RE-EVALUATION FORM

A. Re-evaluation Type: Right of Way Phase, Design Change

Project Name: SR 710 FROM US 441 TO MARTIN CO/L

Project Limits: US 441 to Martin County Line

[\[2 - 419344-3 Okeechobee Utility Authority Realignment Figure 3\]](#)

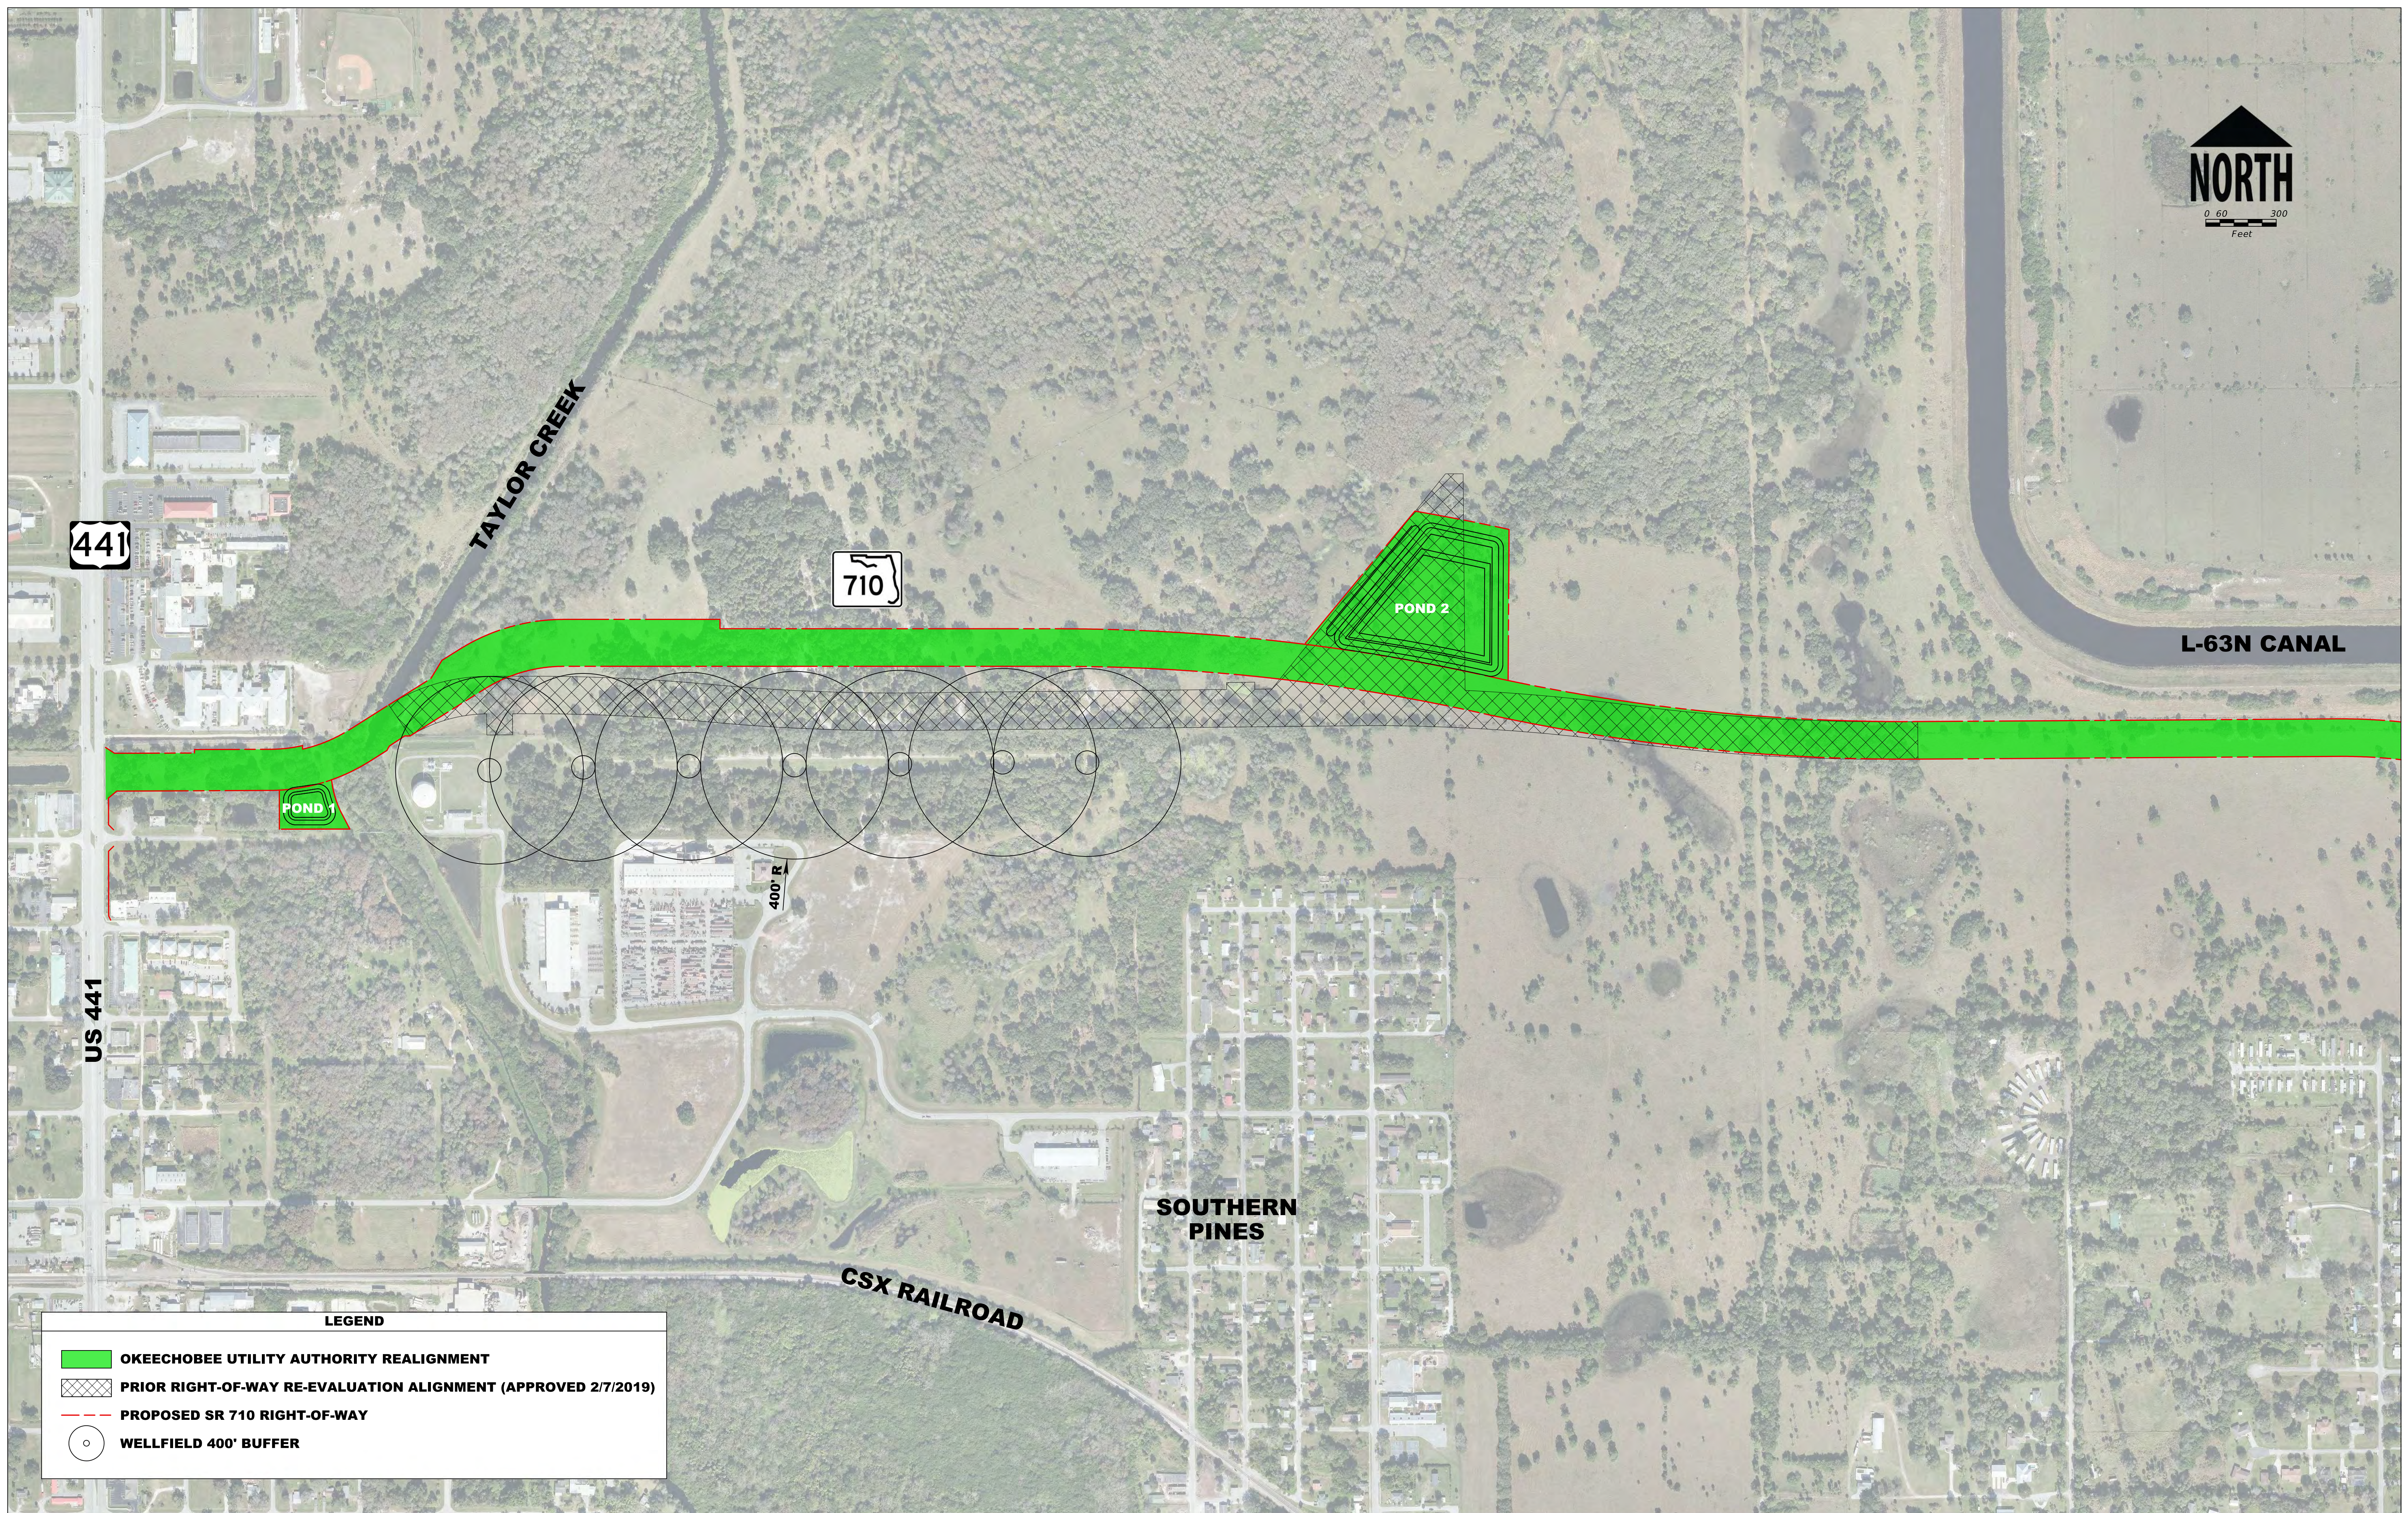
Approximately one mile of the proposed SR 710 extension is being realigned to avoid and minimize impacts to the OUA wellfield protection area, generally within a 400-foot radius around each local well head. Starting approximately 150 feet east of Taylor Creek, the centerline of the road shifts north of the prior 2019 Re-evaluation alignment, before converging

with the prior alignment east of the proposed Pond 2 site. There is no change in the proposed roadway typical section. The maximum difference between the two alignments is 275 feet, occurring near Station 536+00. Refer to **Figure 3** (attached) for a comparison of the original and realigned roadway design. The changes in roadway alignment acreage for the current design requires approximately one acre more of ROW acquisition than the 2019 Re-evaluation design.

As a result of the northern shift of the roadway alignment, the proposed location of Pond 2 required re-design. The footprint for Pond 2 was shifted slightly and its acreage was reduced. A 9.51-acre parcel acquisition (affecting two parcels with one property owner) was required for the 2019 Pond 2 design. For the updated Pond 2, approximately 9.32 acres of parcel acquisition is now required. The same parcels and property owner are affected with the Pond 2 redesign as was originally affected in the 2019 Re-evaluation. The parcel area being acquired includes the entire pond footprint, area necessary to tie down to existing ground and the outfall swale west of the pond site. The actual pond footprint, as measured from the outside top of berm, decreased from 8.25 acres (2019 Re-evaluation design) to 7.43 acres (current design).
